City of Seattle
Seattle Department of Transportation

MEMORANDUM

Date: February 2, 2011
To: Users of SDOT Pavement Opening and Restoration Rule 5-2009
From: SDOT Pavement Engineering and Management
Subject: PORR Revision
ADA Curb Ramp Installation Requirements

Figure 1. Crosswalks and Intersections as defined by Seattle Municipal Code

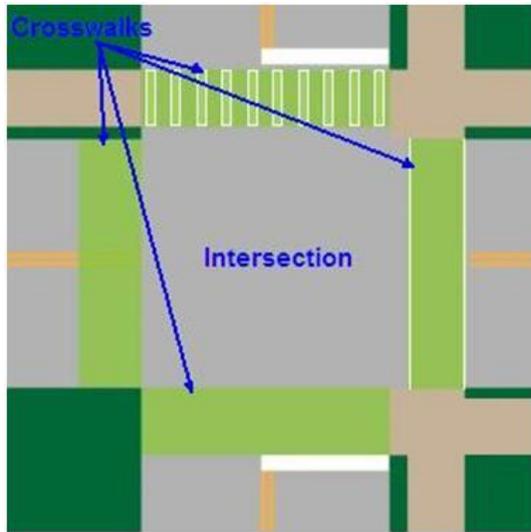
The crosswalk portion of the pedestrian pathway is defined in the Seattle Municipal Code and shown in Figure 1 below, along with the intersection area. Figure 2 shows the areas where a pavement opening would trigger curb ramp upgrades based on the ADA guidelines and the defined pedestrian pathway.

Any time the term "crosswalk" or "intersection" is used in the PORR, the definitions above shall apply. Please note that crosswalks exist regardless of markings.
